STRATFORD EXTENSION PROJECT – SSD – 4966

SUBMISSION BY GLOUCESTER SHIRE COUNCIL TO AN EXHIBITION OF THE ENVIRONMENTAL IMPACT STATEMENT AND DEVELOPMENT APPLICATION

January 2013

Map 1 Stratford Village

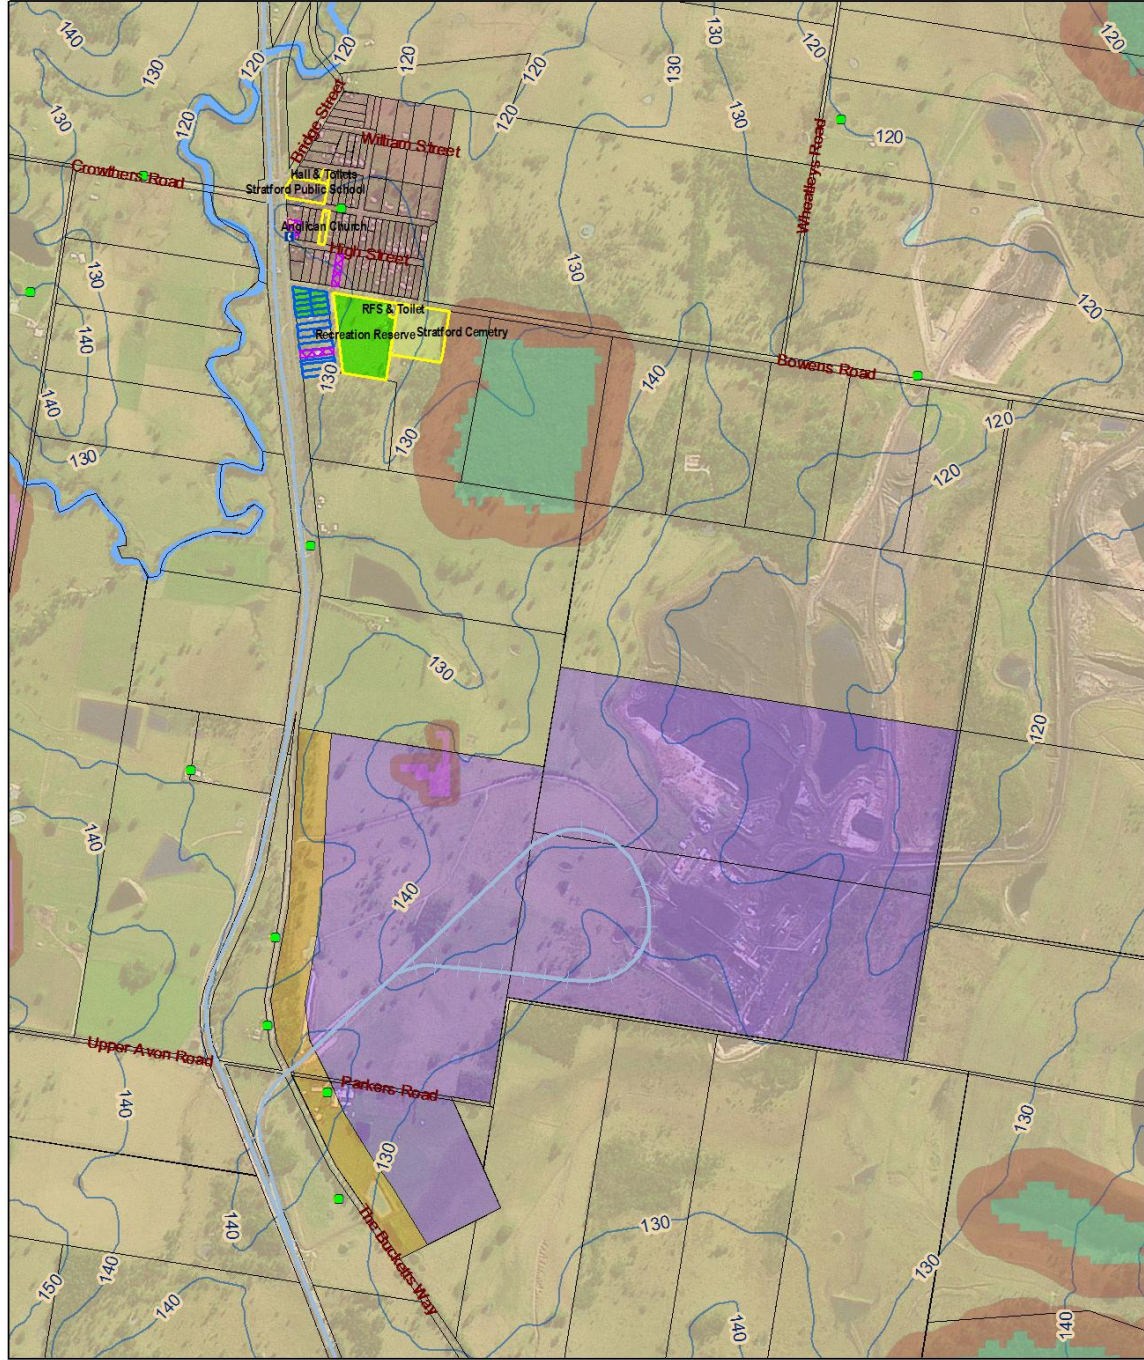
Council and the State Government recently zoned a significant area of land immediately south of the village for industrial purposes (see map three). The rationale for zoning this land for industrial purposes was an endeavour to provide an extended base to the local economy, for large-scale industrial and manufacturing activity. The approval of AGL's CSG field in the Gloucester Valley required a site for gas collection and distribution. AGL also propose a gas-fired electricity generation plant on land in this industrial zoned area. The availability of land, power, rail, road (and possibly large-scale produced water from the CSG production) creates a significant opportunity on this land. The land would provide additional jobs for the marginal economy of the valley.

Map 4 Offset Areas, Wildlife Corridors and Reserves

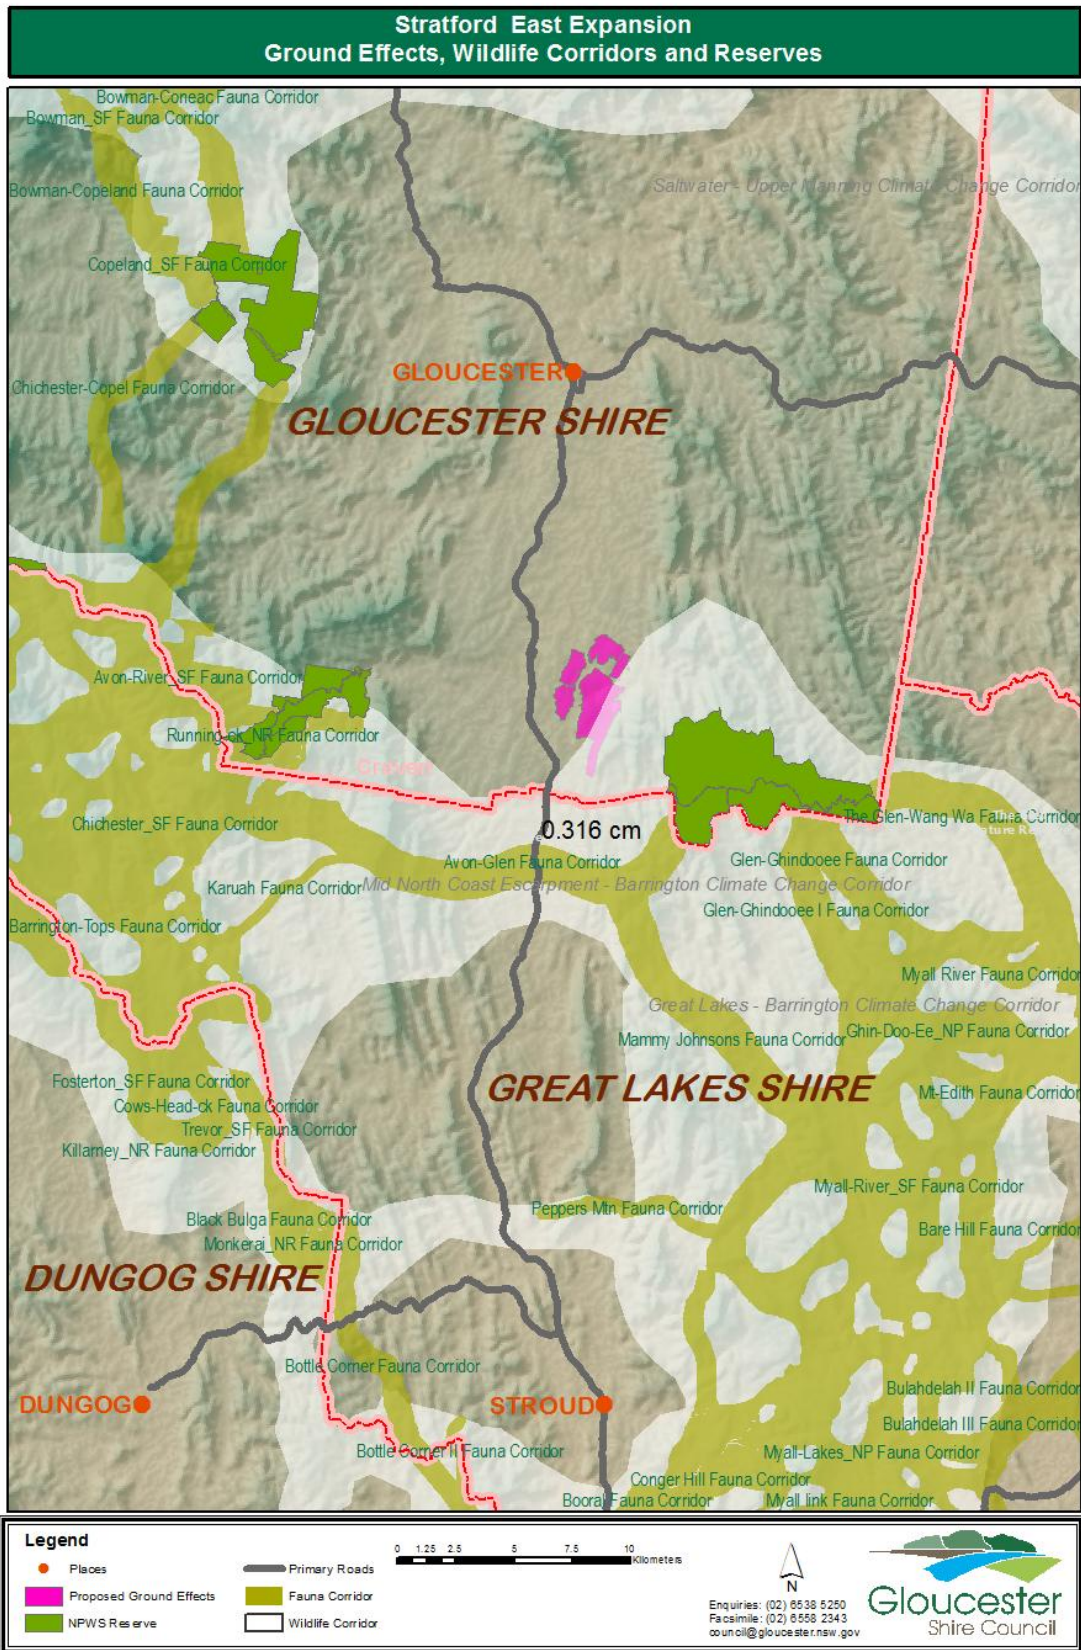
Two of the biodiversity offset areas (areas 3 and 4) proposed in relation to the Stratford Extension Project are located within the wildlife / climate change corridor. Within offset area 3 are two lengths of the Wards River gorge which contains semi-closed riparian forest of particularly high conservation value. Connecting those two lengths of the gorge is an existing Voluntary Conservation area. Combined, a total length of about 1.75km of the Wards River would be included in protected areas if offset area 3 is established.
